Re: CRS Site Draft Technical Impracticability Assessment Response to U.S. EPA January 22, 2013 Comments United States of America v. AK Steel Corporation et. al. Case No. 1:10-cv-00996-KMO Chemical Recovery Systems Site, Elyria, Ohio

RE: Response to EPA Comments on Draft Technical Impracticality Waiver Assessment Report
United States of America v. AK Steel Corporation et. al. Case No. 1:10-cv-00996-KMO
Chemical Recovery Systems Site, Elyria, Ohio.

This letter provides responses to USEPA's remaining comments on the TI Assessment. For ease of review, this letter restates USEPA's comments below in *italics* followed by the Group's response.

Figure 4-2

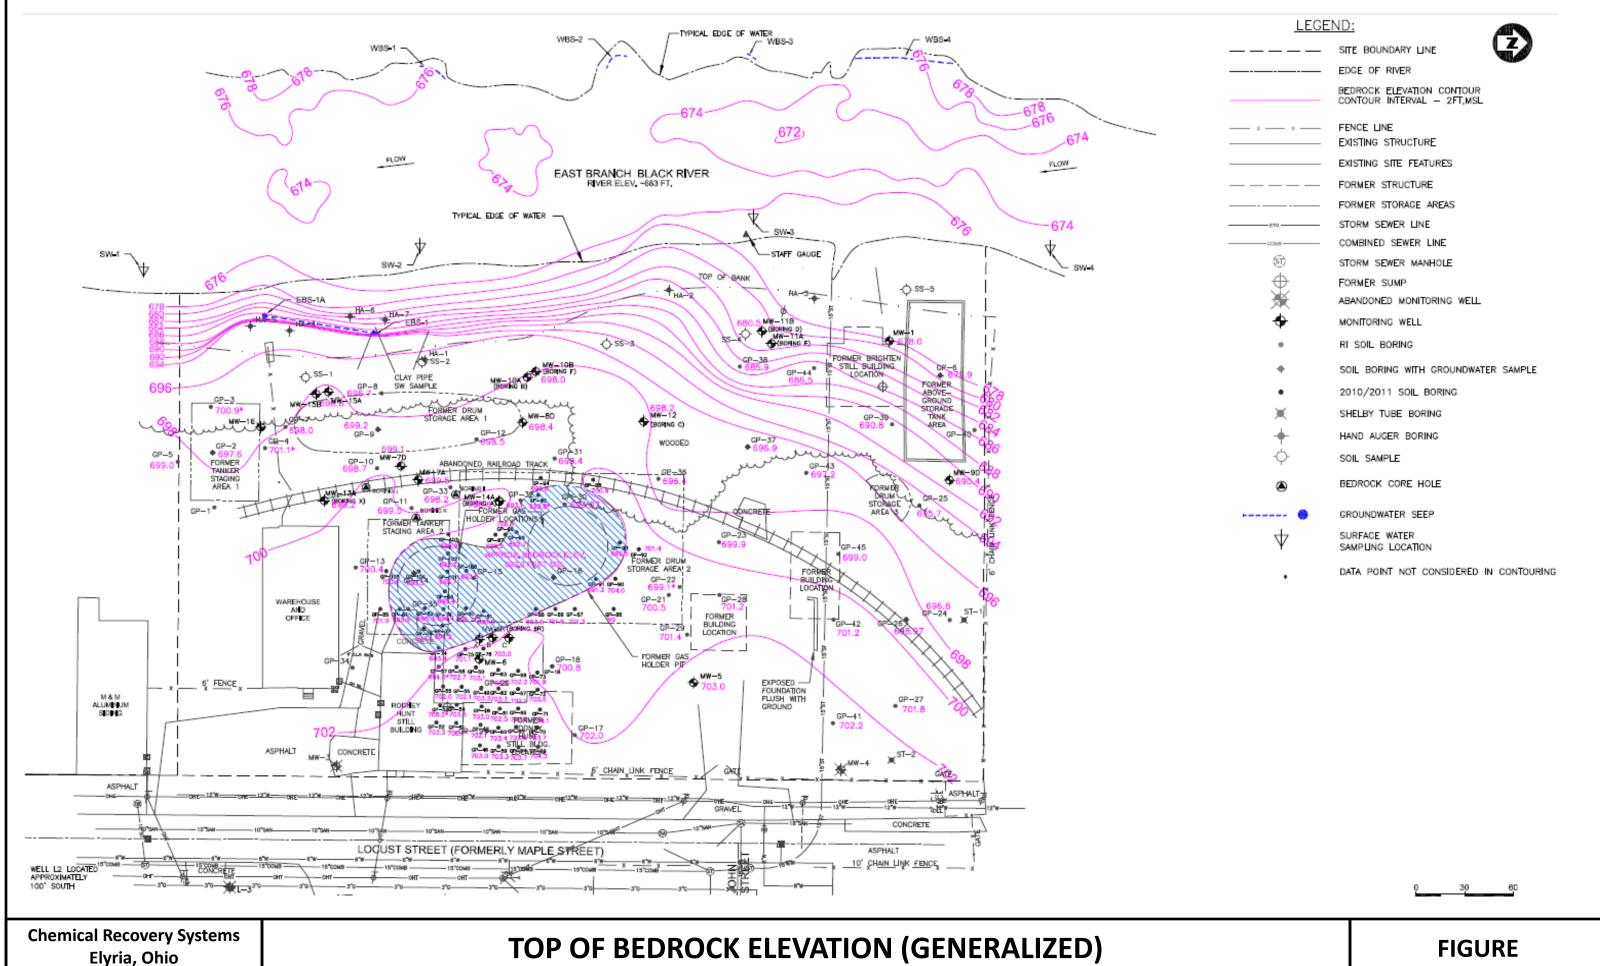
In the fourth paragraph, reference is made to Figure 4-2. This is absent; please provide.

Figure will be inserted. A copy of the proposed figure is provided as Attachment 3.
